Appln. No. 10/823,016
Reply to Office Action of Sep. 20, 2005

Amendments to the Drawings:

REMARKS

1/3

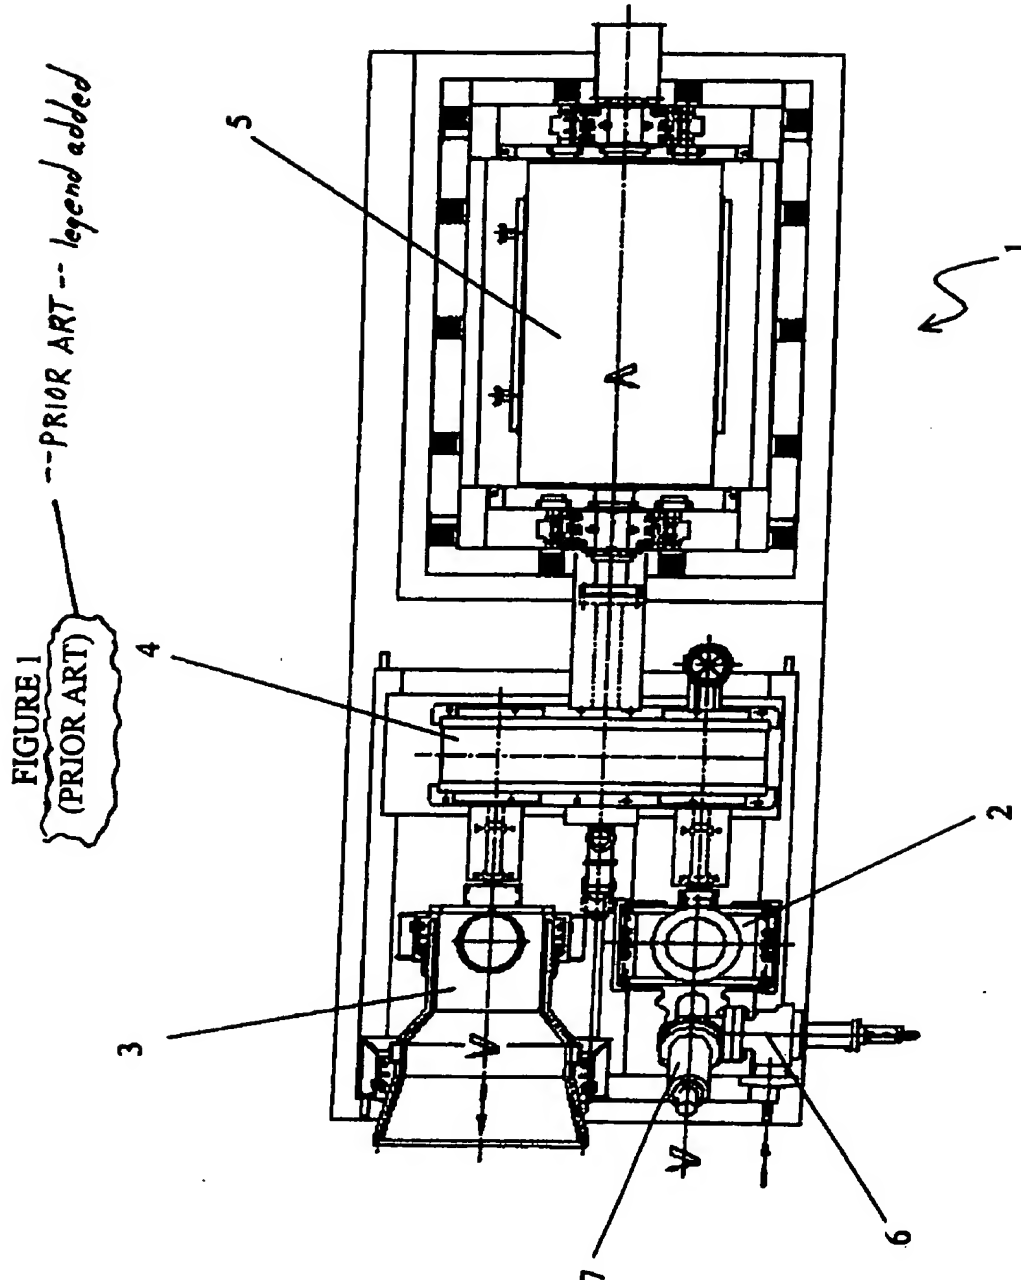
The attached sheets of drawings include changes to Figs. 1 and 3. Fig. 1 has been amended to include a --Prior Art-- designation. Fig. 3 has been amended to identify the convergent/divergent channel as item 26. No new matter has been added.

In the drawings, Figure 1 is amended to include the legend --Prior Art--, and Figure 3 is amended to indicate as item 26 the converging/diverging channel, which is shown in the as-filed drawings. No new matter has been added.

Figure 1 is objected to as lacking a legend such as --Prior Art-- because only that which is old is illustrated. In amended Figure 1, the legend --Prior Art-- has been added. Accordingly, Applicant respectfully requests that this objection be withdrawn.
